Queenstown Control Zone

Joint Petition for Amendment

Volume 1 Version 3.0

31 October 2025

5.3 Delete four VFR Advisory Routes:

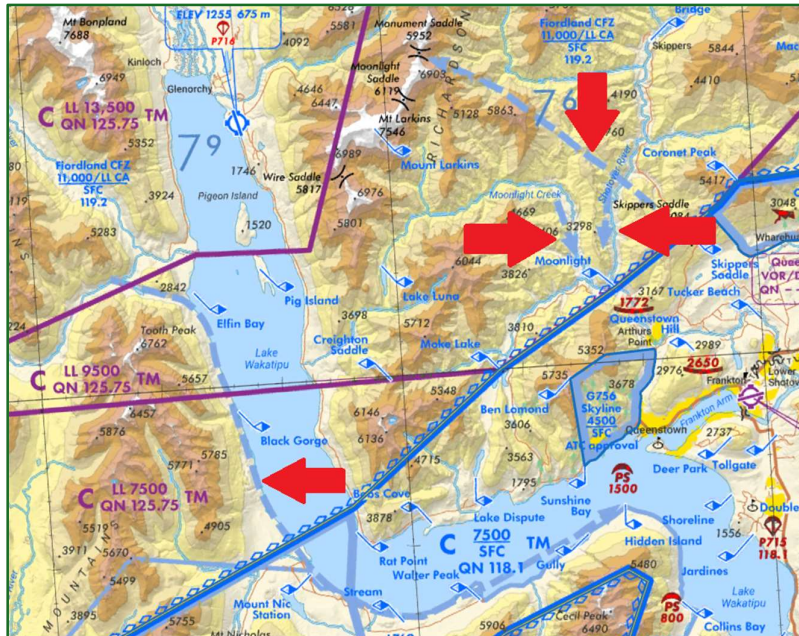
- ▶ Inbound from Elfin Bay via Black Gorge into the QN CTR/C
- ▶ Outbound from Skippers Saddle VRP away from QN CTR/C.
- ▶ Both inbound to Moonlight VRP towards QN CTR/C.

VFR Advisory Routes indicated on the VNC should be removed to better align with current operations and future procedure changes resulting from aerodrome masterplan infrastructure changes.
